UNITED STATES PATENT AND TRADEMARK OFFICE

Office Action Summary	Application No. 09/986,956	Applicant(s) BARBOSA, MANUEL	
	Examiner Lan Nguyen	Art Unit 3683

Dual Leading-Shoe Drum Brake
Barbosa
U.S. Serial No. 09/986,956.

FIG. 2 PROPOSED

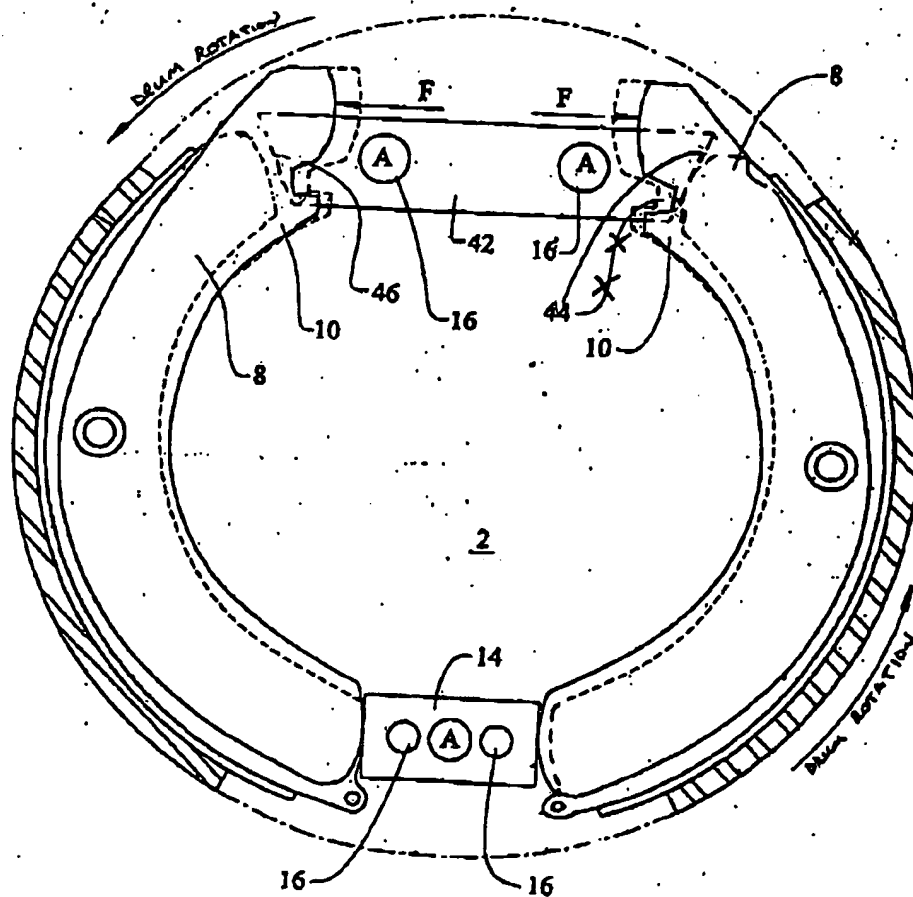
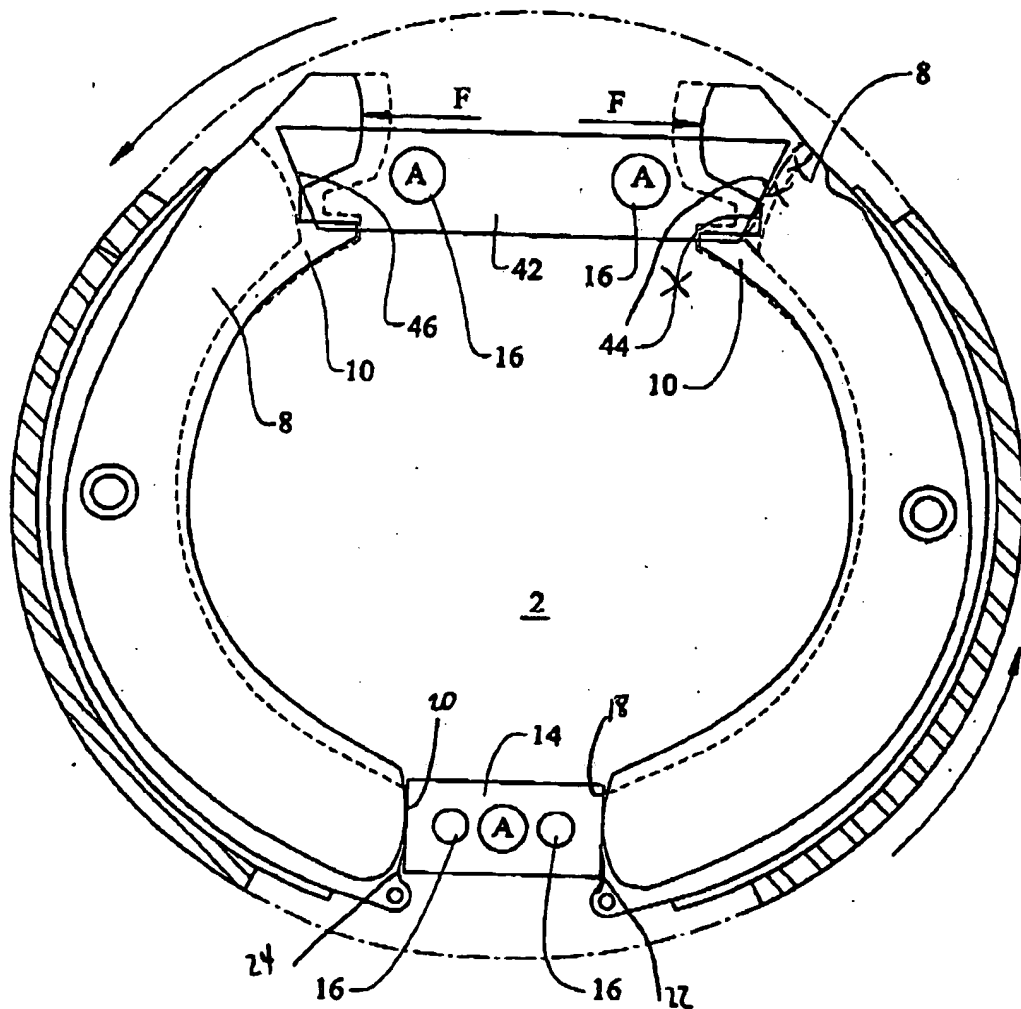
1. The proposed two sheets of figure 2, submitted on 3/28/05, are not approved because the faxed copies are of poor quality; and the proposed changes are very hard to see.

NOT approved
XLN
6/18/05

NOT approved
6/18/05
XLW

2. It is noted that Applicant again did not respond to the drawing objections stated in the Office Actions dated 5/6/03 and 12/24/03.
3. Corrected drawing sheets in compliance with 37 CFR 1.121(d) are required in reply to the Office action to avoid abandonment of the application. Any amended replacement drawing sheet should include all of the figures appearing on the immediate prior version of the sheet, even if only one figure is being amended. Each drawing sheet submitted after the filing date of an application must be labeled in the top margin as either "Replacement Sheet" or "New Sheet" pursuant to 37 CFR 1.121(d). If the changes are not accepted by the examiner, the applicant will be notified and informed of any required corrective action in the next Office action. The objection to the drawings will not be held in abeyance.
